**Re. Response to Council further information requests for the EB2 Application Package**

I am writing in regard to Auckland Council's (the Council) further information request letter of 9 September 2022 for the Eastern Busway 2 (EB2) application package. A separate s92 response will be provided for the Eastern Busway 3 Residential (EB3R) application package later in November.

**Figure 2: Location of EB2-EB3R Boundary on Ti Rakau Drive**

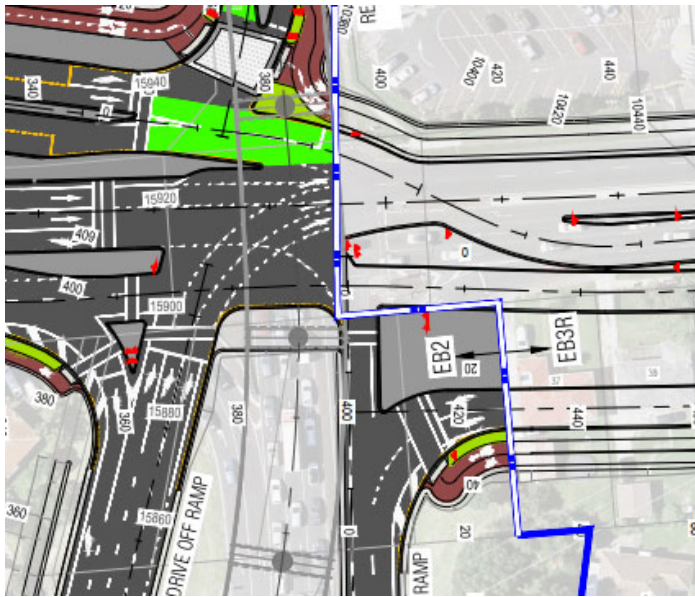
5. *The designation map boundary (Land Requirement Plan.pdf) does not conform to the EB2/EB3 boundary on most of the other plans (i.e. the Reeves Rd/ SEART and Te Rakau Drive intersection). Please confirm this boundary and update the map.*

The EB2/EB3 boundary as shown on the designation map boundary is the correct boundary for the NoR as shown below in the drawing excerpt below. This boundary is located at the intersection of SEART/Ti Rakau Drive and Reeves Road.

Given the above, AT does not propose to make any alterations to the Land Requirement Plan or the associated consent drawings for EB2.

**Figure 3 – Location of Noise Wall**

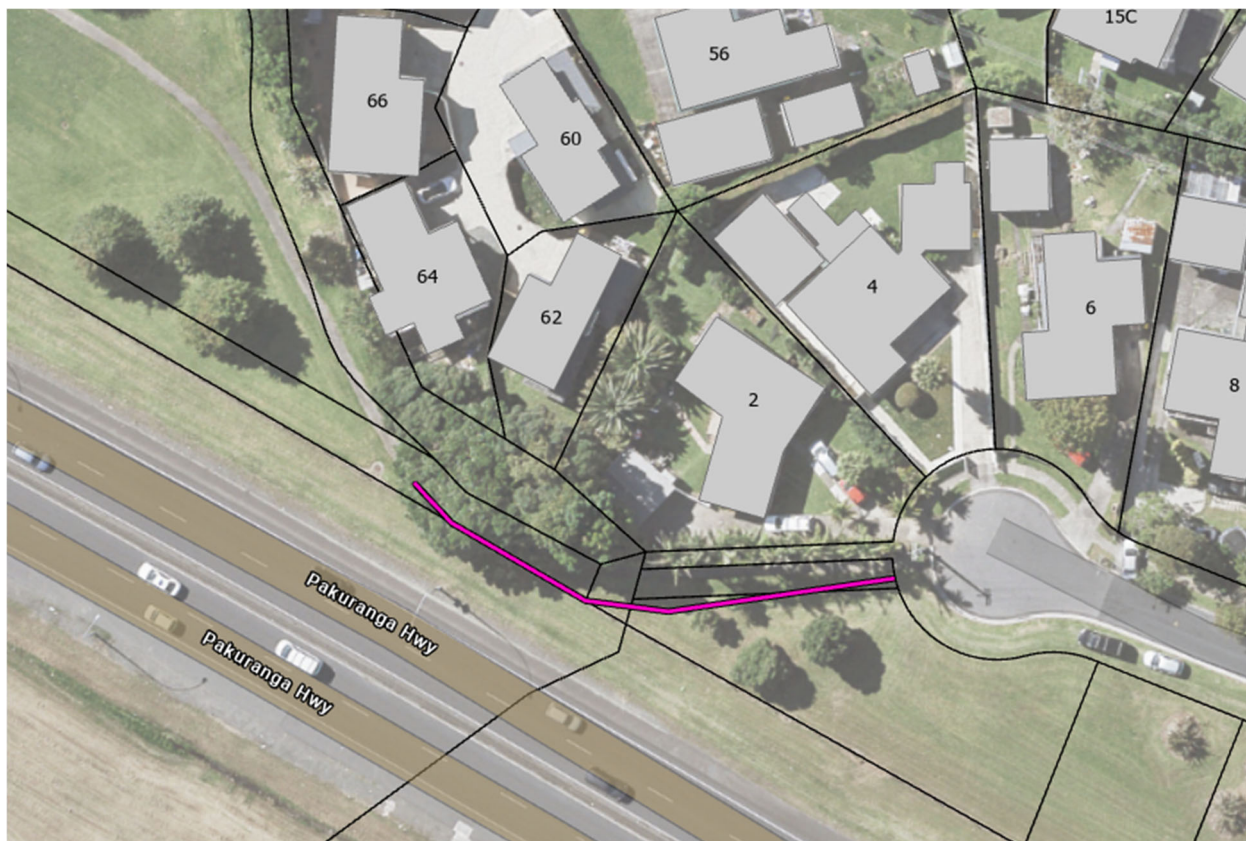
*Please provide more informative comment on the actual and potential benefits of barriers in a more holistic sense, that includes the potentially significant benefits at lower levels. The evaluation of the utility of barriers should be revised to have proper regard to the potentially significant benefits they can have at the ground floor.*

However, in response to the question, we have now considered noise barriers at two-storey PPFs in NZS 6806 Category B or C that could benefit in noise reductions at the ground floor.

There were 6 PPFs across EB2 that were predicted to be in either Category B or C in the Do Minimum scenario and are double storey. Of these, only 1 PPF (62 Dale Crescent) did not have a driveway facing the road, such that noise barriers would be able to break line-of-sight to the roads at ground floor.

However, we note that a noise barrier at 2 Dale Crescent is already included in the recommended mitigation option and the same noise barrier will also reduce noise levels at the ground floor of 62 Dale Crescent. An image showing the extent of this noise barrier in red is presented below.
